**Re:** BusConnects Lucan to City Centre Core Bus Corridor Scheme  
Lucan to Dublin City Centre

ABP case ref: 314942

## **BUSCONNECTS LUCAN CORE BUS CORRIDOR SCHEME**

Figure 2 Bus stops with inadequate bus stop islands for cycling on Con Colbert Road near Memorial Road

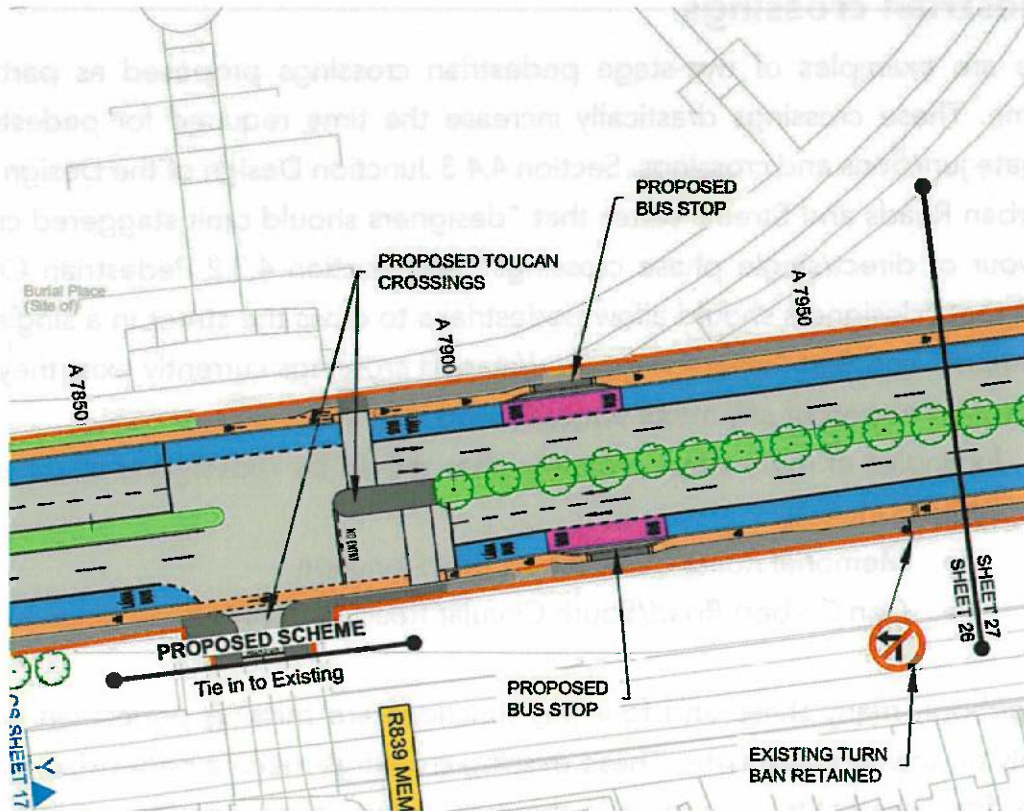
A major concern throughout the Proposed Scheme is the width of the bus stop islands that are proposed. Bus stop islands are crucial for the safety of cyclists and for encouraging all ages and abilities to use cycling infrastructure by removing conflicts between buses and bicycles. However, narrow islands place cyclists in conflict with boarding and alighting bus passengers.

Figure 2 shows how the maintenance of two excessively wide general traffic lanes in each direction on Con Colbert Road forces pedestrians and cyclists to share a very narrow, unprotected space next to a dangerous road. Reducing the number of general

- traffic lanes at this junction would increase journey times slightly for private motorists
- but more importantly would give the design team sufficient room to build a safe environment for all ages accessing Memorial Gardens and its schools and clubs by foot, bicycle and bus.

Figure 3 Cross section T-T: Excessive 3.5m lanes proposed beside shared space for pedestrians and cyclists on Palmerstown Bypass

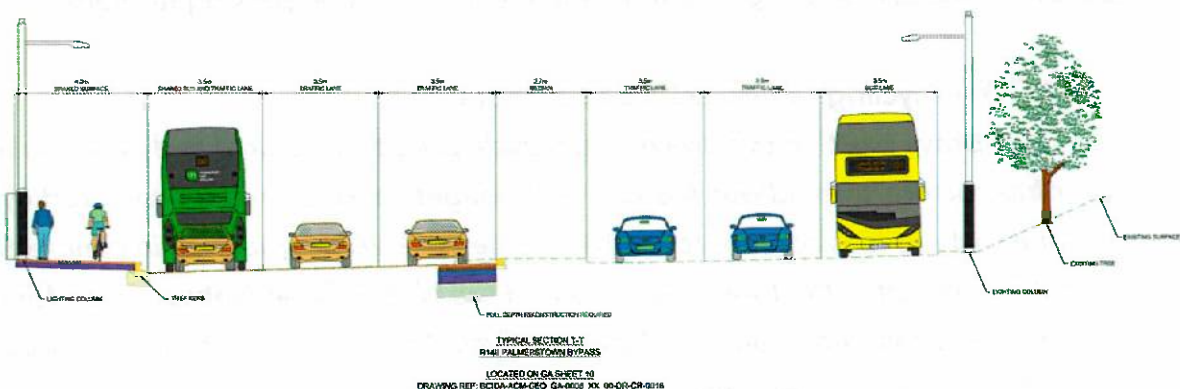
The scheme proposes lane widths of 3.3m and up to 3.5m for general traffic which encourages speeds well beyond the proposed speed limits. Often, these excessive widths are proposed beside cycle lanes with inadequate width or areas with shared space for pedestrians and cyclists which is undesirable. These general traffic lane widths should be reduced to enable lower speeds and reallocated to cycle lanes and footpaths.

## St. John's West/South Circular Road junction

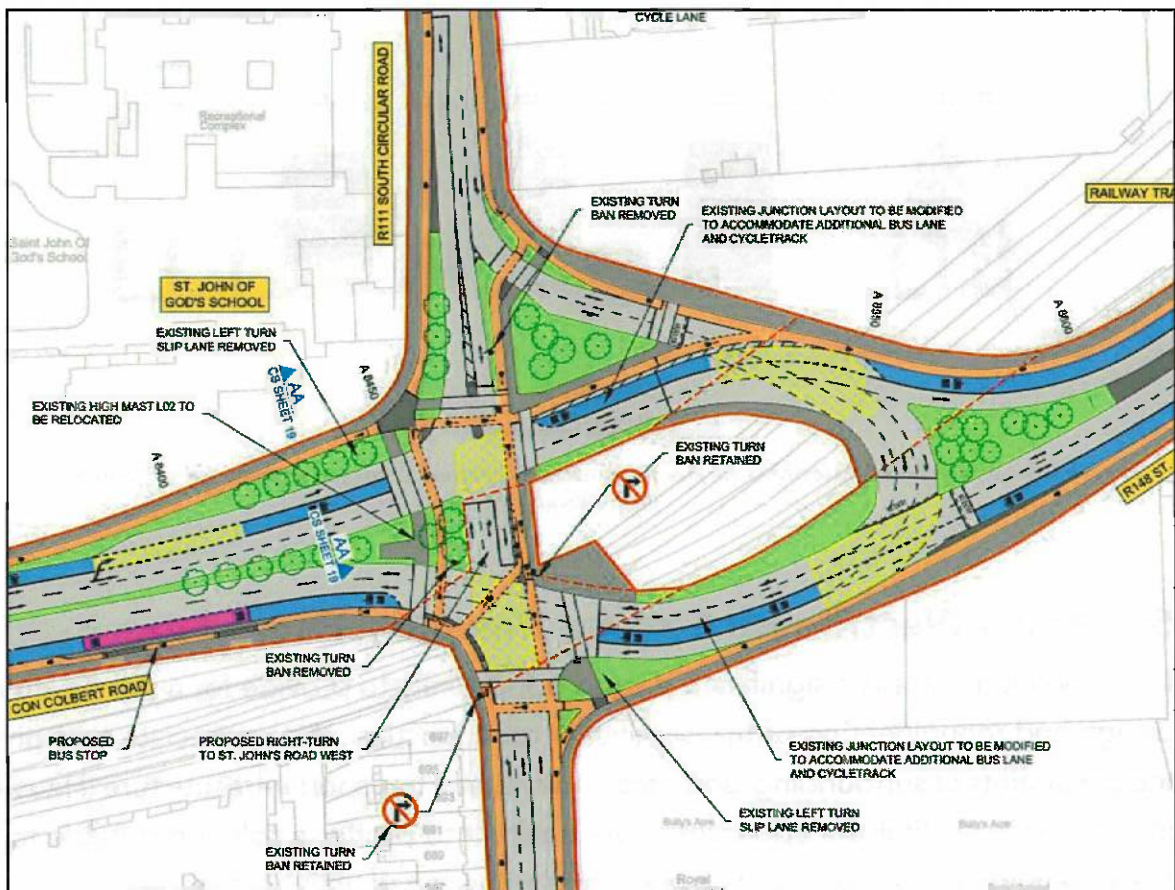
In our opinion there is a significant missed opportunity to provide for a significant re-design and reengineering of this significant road junction. We appreciate that given the constraints of surrounding land uses and national transport infrastructure (Heuston mainline railway) that the applicants were hesitant to proffer a solution suitable to all road users for an improved public realm and provision of active travel.

Once again, we object in the strongest terms to the use of shared space where turning movements may be required for cyclists. We also express concern that the provision of new updated landscaping does not provide for an enhanced public realm. Rather in main instances it reduces the available space for the segregation of walking and cycling. Given the nature of this junction as a semi- roundabout it is our firm belief that this will not be a public space enjoyed by the general public for social activity or

Whilst there are some minor improvements worthy of praise such as the removal of slip lanes, there are still dedicated turning lanes which overlap bus lanes, and create further conflict with cyclists depending on the staging of traffic lights and crossing times at each arm of the junction. Again, the removal of a general traffic lane between this junction and the Memorial Road junction would facilitate more efficient, safer design in line with the decarbonisation goals of this project.
